UI BULLETIN # 92

SUBJECT: **Generator Not Charging Properly (Re-program ECM For Correct Generator)**

MODELS AFFECTED:
Chevrolet Express Van
GMC Savana Van

MODEL YEAR(S):
2010

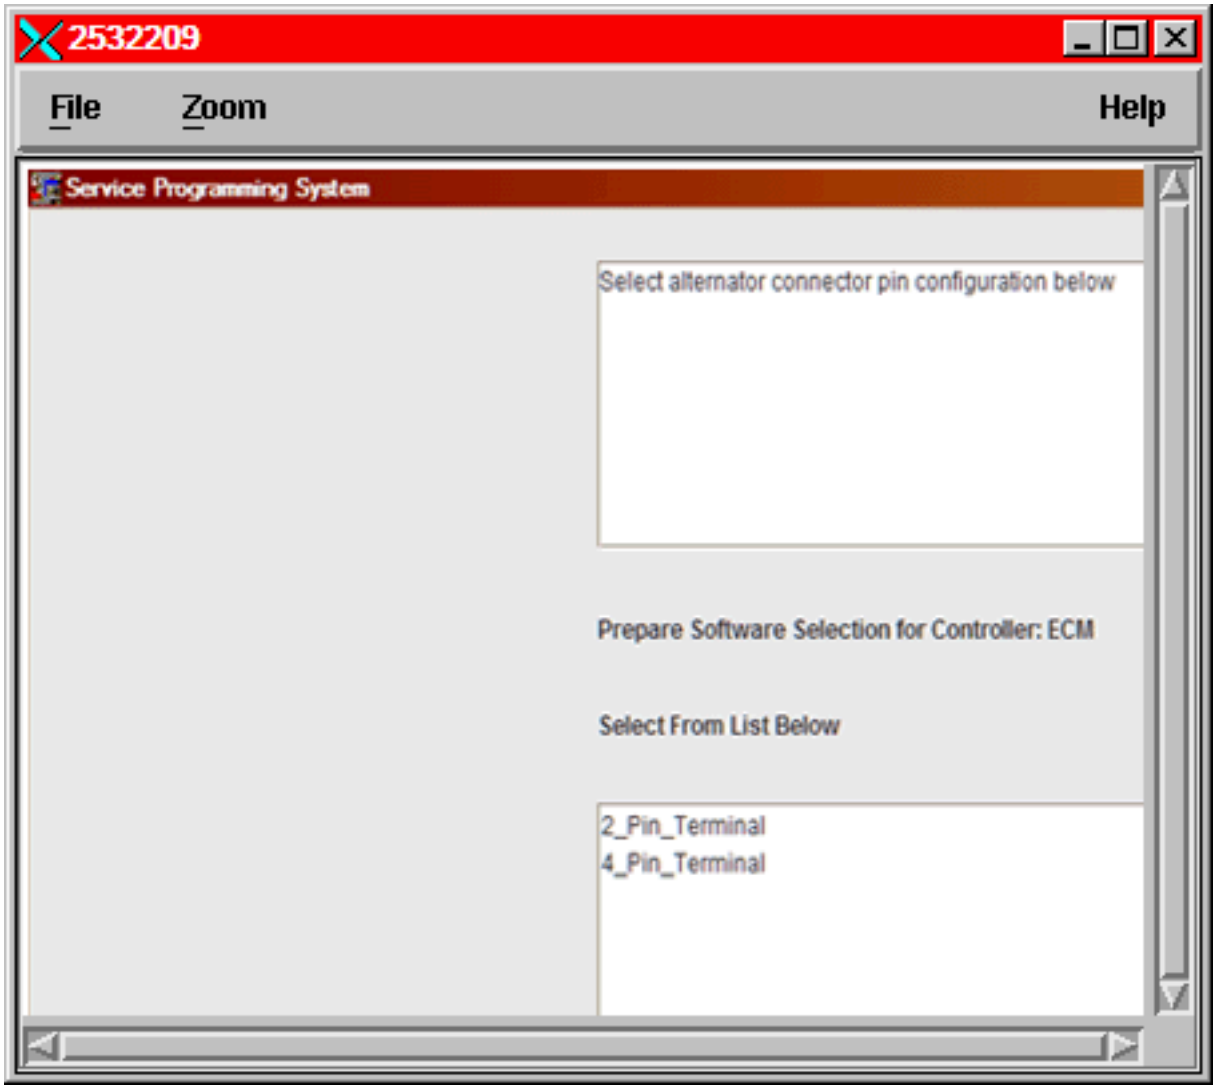
Some concerns of the generator not charging or not operating correctly have been received. This concern could be caused by the ECM being programmed improperly. When programming the ECM there is a selection for the generator pin configuration, as shown below. If the wrong selection is made the generator will not operate properly.

NOTE: If a generator is replaced and the pin configuration is different from the one removed the ECM will also need to be reprogrammed for the new pin configuration.

Program the ECM for the correct generator pin configuration.
